PLANNED UNIT DEVELOPMENT

STAFF REPORT Date: March 15, 2007

DEVELOPMENT NAME Mobile Branch Partnership

LOCATION 1915 West I-65 Service Road North

SITE PLAN

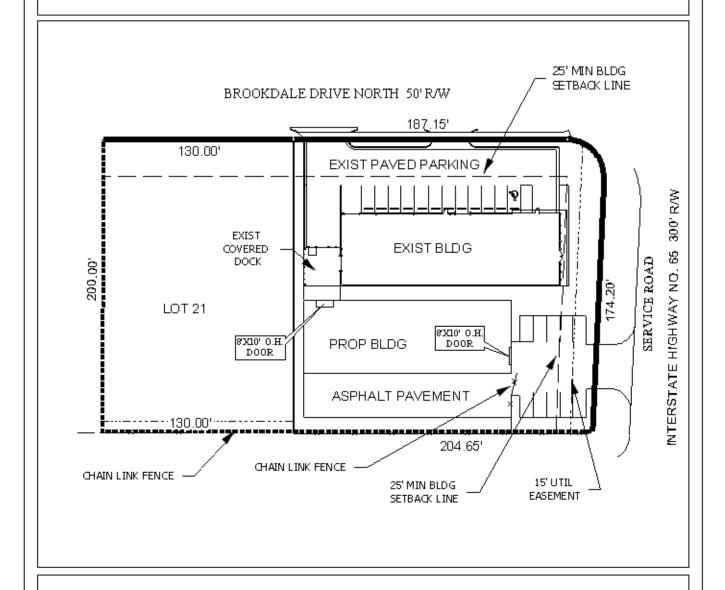
The plan illustrates the existing and proposed buildings, landscaping and green area, 12 existing parking spaces, and 9 proposed parking spaces. However, the plan does not illustrate compliance with the tree requirements of the Ordinance. As the proposed building exceeds 50% of the square footage of the existing building, full compliance with the landscaping and tree requirements of the Ordinance would be required. Additionally, since this site received a sidewalk waiver in 2004; therefore, no sidewalk along West I-65 Service Road West is required.

A 12' x 14' overhead door illustrated on the plan within 58-feet of the front property line, is a concern. Section 64-6.B.2 of the Zoning Ordinance, Off-street loading facilities states "Each large space shall have an overhead clearance of at least fourteen (14) feet, shall be at least twelve (12) feet wide, and shall be at least fifty (50) feet long exclusive of access or maneuvering area, platform, and other appurtenances". Therefore, if this site provides large truck loading the site plan must be revised to reflect the Off-street loading facilities requirements. Additionally, no dumpster is illustrated on the site plan.

RECOMMENDATION Based on the preceding, this application is recommended for holdover until the April 19th meeting to allow the applicant to address the following: 1) Provide information regarding Off-street loading facilities on the site plan; and 2) Illustrate dumpster location, access and screening on site plan. Information and revised plans must be submitted by March 26th.

The application was heldover from the March 15th meeting to allow the applicant to provide information regarding the Off-Street loading facilities on the site plan and to illustrate the dumpster location, access and screening on the site plan. A revised site plan was provided to staff on March 22nd depicting the proposed PUD, reducing the overhead door on the I-65 frontage.

<u>RECOMMENDATION</u> Planned Unit Development: This application is recommended for Approval, subject to the following conditions:

- 1) The placement of a note on the PUD plan stating that deliveries and truck shipment will not be made at this building;
- 2) Full compliance with the landscaping and tree requirements of the Ordinance; and
- *3) full compliance with all other municipal codes and ordinances.*
